SERVICE BULLETIN

NUMBER: 09-80-21
DATE: 02/28/22

SUBJECT: DTC # P2682 & P26Ax** / Thermo Control Valve – Design Change

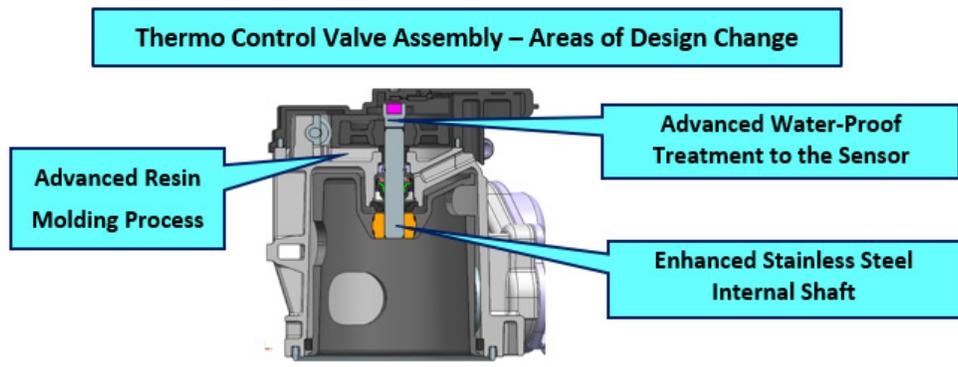
This bulletin announces availability of a new thermo control valve assembly. The new valve contains an enhanced stainless steel internal shaft for optimized durability along with advanced water proofing for the sensor portion. A new resin molding process was also used in production. These changes were implemented prevent sensor corrosion which can cause DTCs P2682 and/or P26A**.

Quantity	Part Description	Part Number
1	VALVE ASSEMBLY-THERMO CONTROL	21319AA010
2	GSKT-INT MANIF**	14035AA78A
1	PIPE AY-FUEL DLVY**	17540AA460
1	EGR GASKET**	14738AA210

NOTE: The new valve assembly comes with a replacement o-ring.

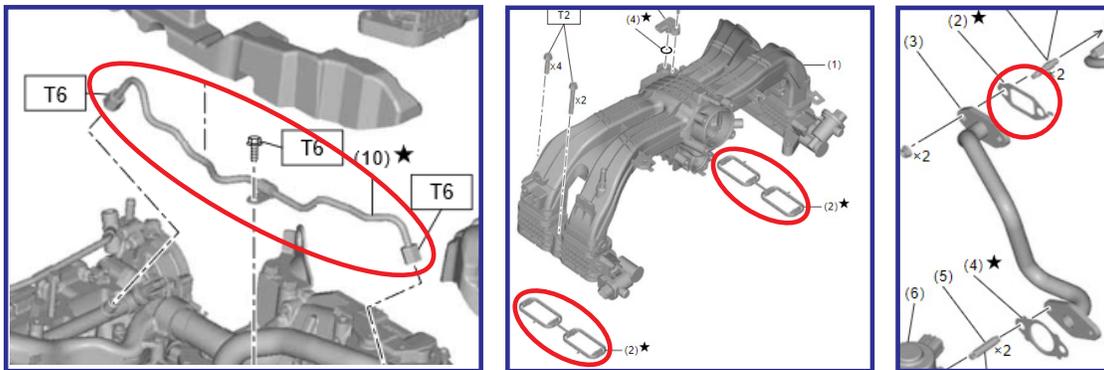
- The Service Manual uses a black star (★) in the component breakdown illustrations to indicate one-time use parts. The high-pressure fuel delivery pipe, intake manifold gaskets, and EGR cooler gaskets are one-time use parts (shown below).
